KINGSTON STEAM PLANT - ANNUAL ASH POND DIKE INSPECTION

KINGSTON STEAM PLANT - ANNUAL ASH POND DIKE INSPECTION

On the attached print of 10N400 the different areas are designated.

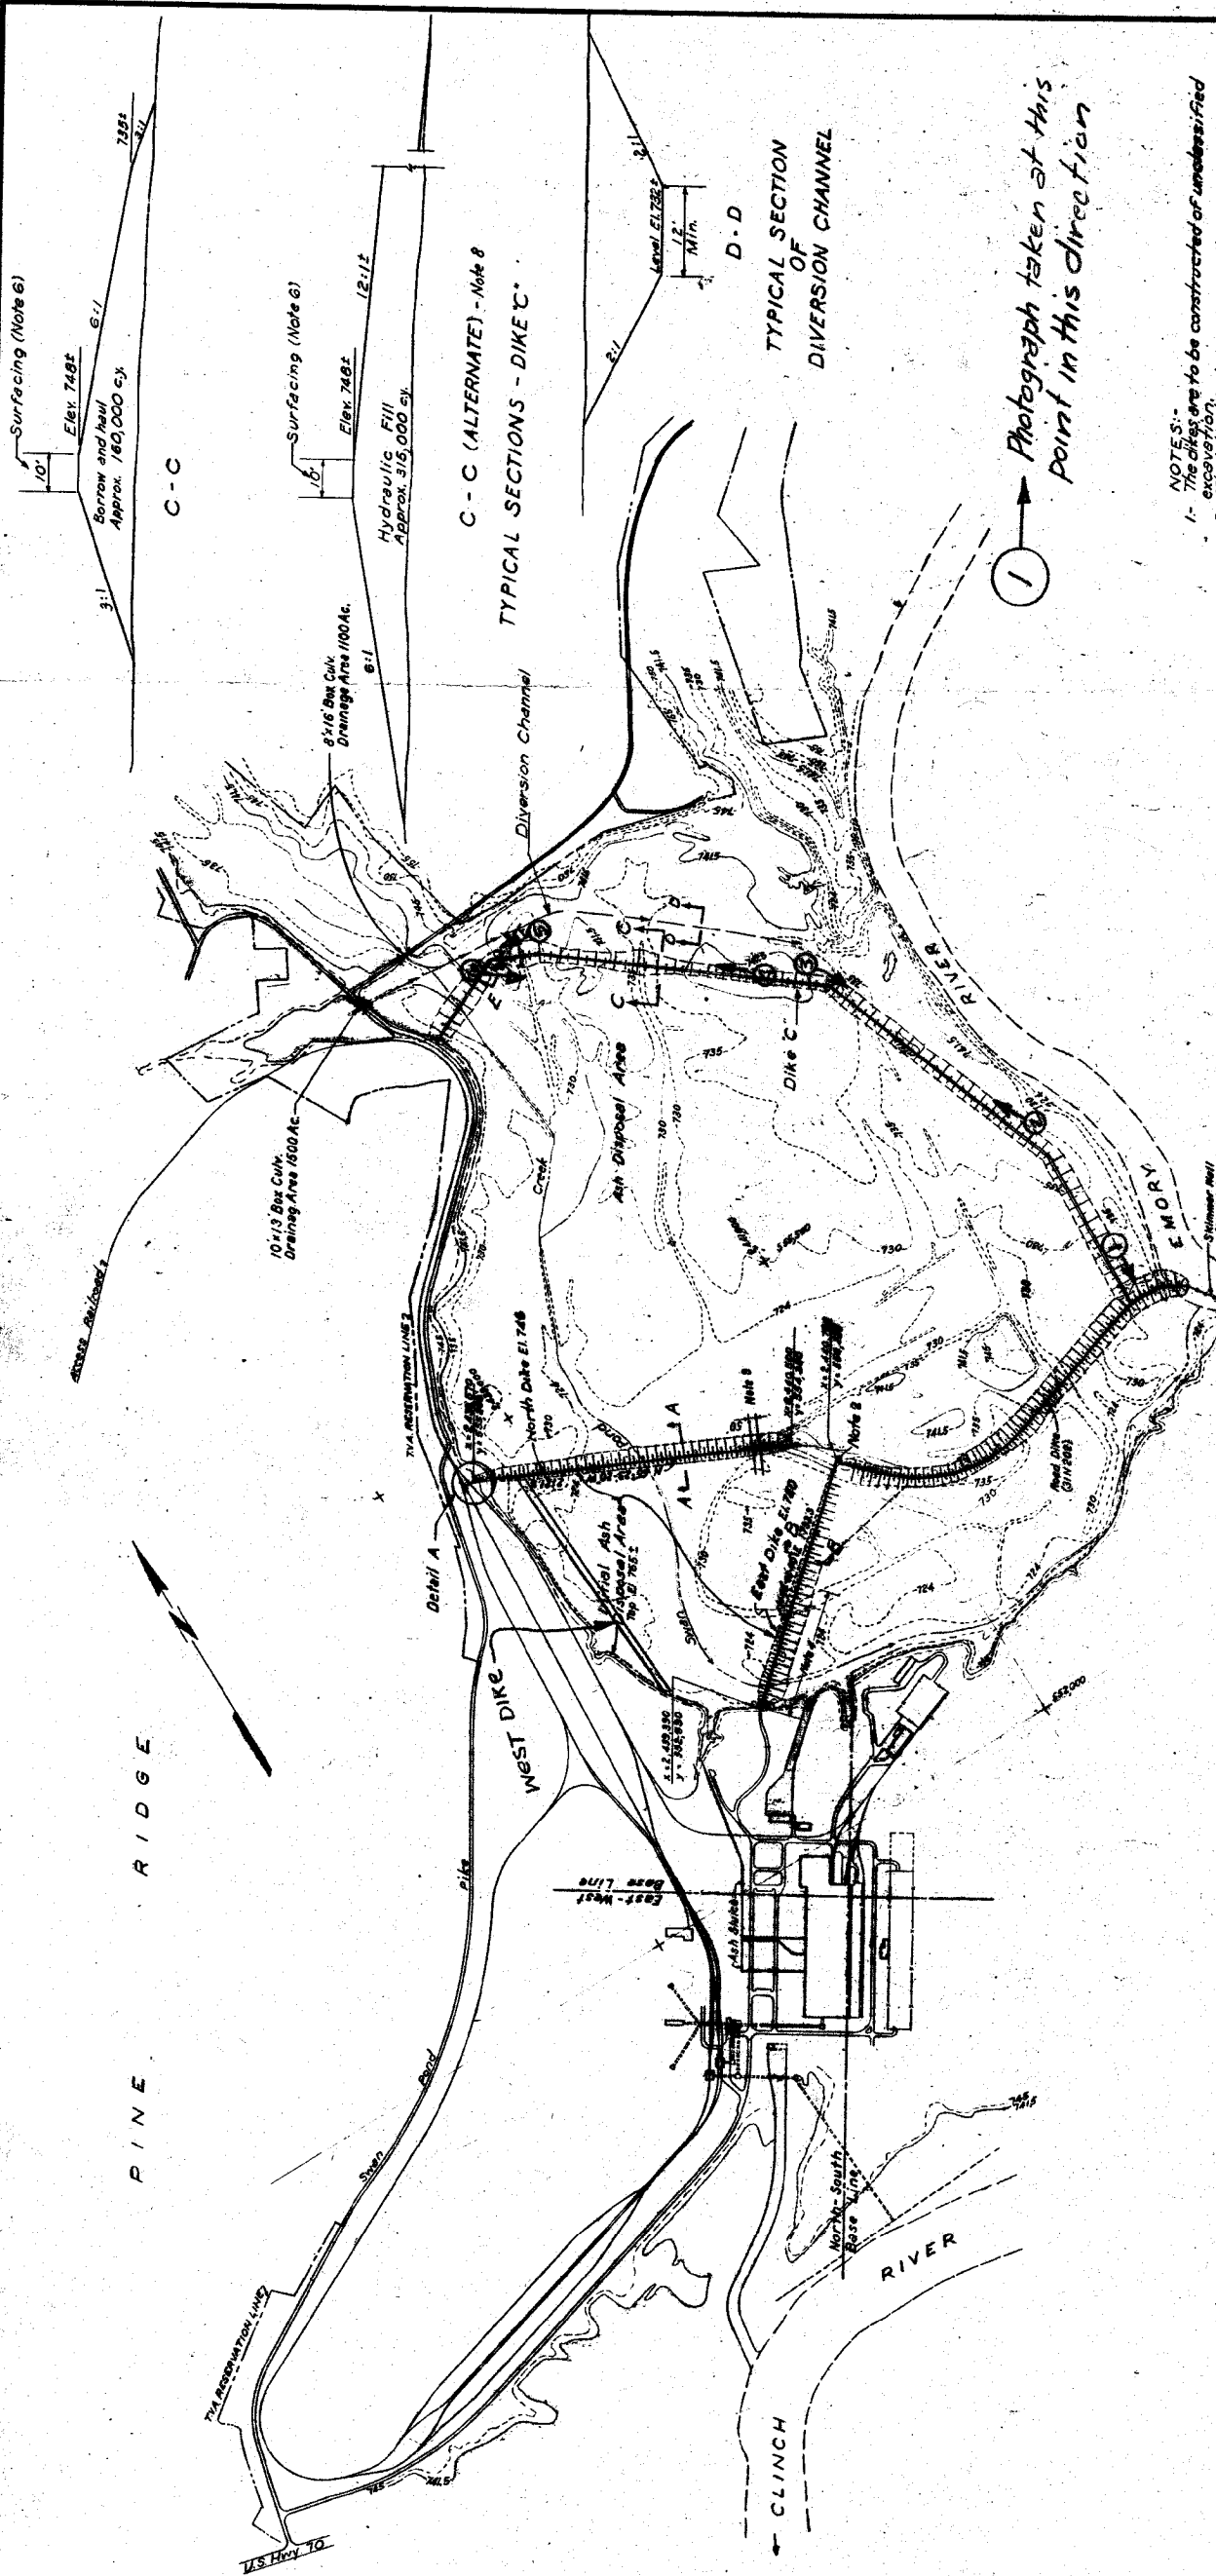
In general, the dikes are in good shape, and there appears to be no stability problem. The original dikes were constructed of earth. The dikes around the initial ash area were raised with ash. In the last year a great deal of work has been done on dike C and the road dike. These two dikes are being raised with earth and ash.

1. Continue grassing the earth slopes.
2. Keep logs and trash removed from the outside slope of dike C.
3. Raise dikes, with earth and ash, as required to maintain 4-foot freeboard in the pond, keeping the top of dike smooth and sloped to the inside. The top of the original dikes shall be left as a berm and the dikes raised with slopes of 2:1 on the inside and 3:1 on the outside with 16-foot top width. The maximum height of each lift shall not exceed 10 feet before providing a berm.

⑤

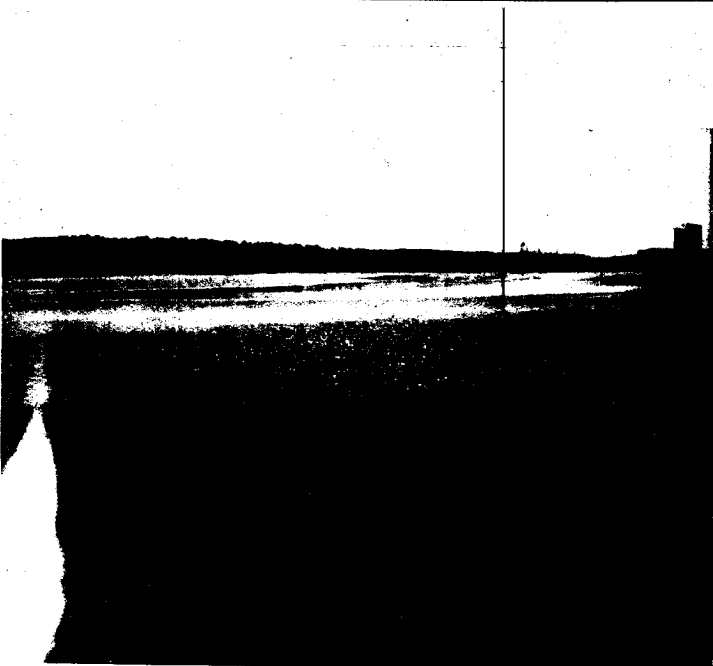
Since last year's inspection, fill around the northern spillway discharge pipe has been excavated from the spillway to near the middle of the dike, portions of the pipe replaced, the excavated portion backfilled with carefully compacted earth, and all the joints in the pipe grouted from the inside. This has eliminated seepage along the outside of the pipe. Both spillways have been raised two feet; and to maintain a 4-foot freeboard in the ash pond, dike C has been raised approximately two feet. Standard skimmers (picture 6) have been installed, and a concrete end wall (picture 5) has been constructed at the spillway outlet. There were no signs of any fly ash escaping through the spillway.

*Concrete endwall at spillway
outlets.*
